**NPDES PERMIT FACT SHEET
ADDENDUM**

Application No. PA0037052
APS ID 605167
Authorization ID 1352649

Applicant Name	<u>Pen Argyl Borough Municipal Authority</u>	Facility Name	<u>Pen Argyl Wastewater Treatment Plant</u>
Applicant Address	<u>11 North Robinson Avenue Pob 128</u> <u>Pen Argyl, PA 18072-1452</u>	Facility Address	<u>249 South Main Street</u> <u>Pen Argyl, PA 18072-9520</u>
Applicant Contact	<u>John Cuono, Authority Chairman</u>	Facility Contact	<u>David Mondello, Operator</u>
Applicant Phone	<u>(610) 863-4119</u>	Facility Phone	<u>(610) 863-5422</u>
Client ID	<u>62404</u>	Site ID	<u>255664</u>
SIC Code	<u>4952</u>	Municipality	<u>Pen Argyl Borough</u>
SIC Description	<u>Trans. & Utilities - Sewerage Systems</u>	County	<u>Northampton</u>
Date Published in PA Bulletin	<u>June 4, 2022</u>	EPA Waived?	<u>Yes</u>

Subject: Pen Argyl WWTP NPDES Permit Renewal (No. PA0037052)
Draft NPDES Permit Appeal

StreamStats Report

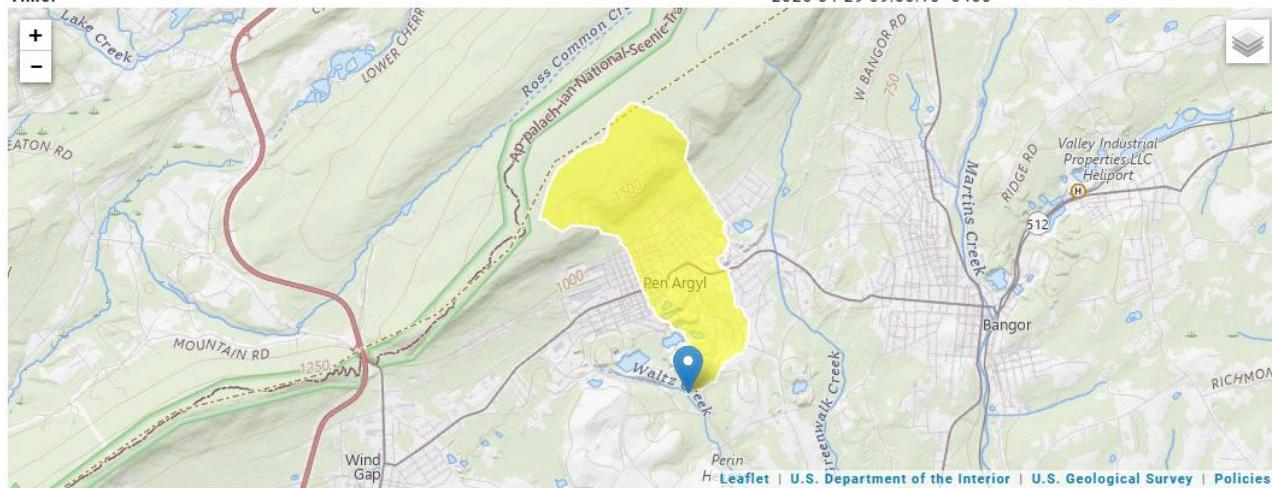
Modeling was also re-run using the new POFU location. There is no stream mapping of the Unnamed Tributary to Waltz Creek in eMapPA. Therefore, the RMI values were obtained by using the measure tool on USGS StreamStats where the Unnamed Tributary is represented. The drainage areas were also obtained using USGS StreamStats. The statewide default Low Flow Yield (LFY) of 0.1 cfs/mi² was used for modeling because the USGS StreamStats drainage area is too small to estimate accurate low flow values. Modeling can be observed on pages 5-7 of this fact sheet.
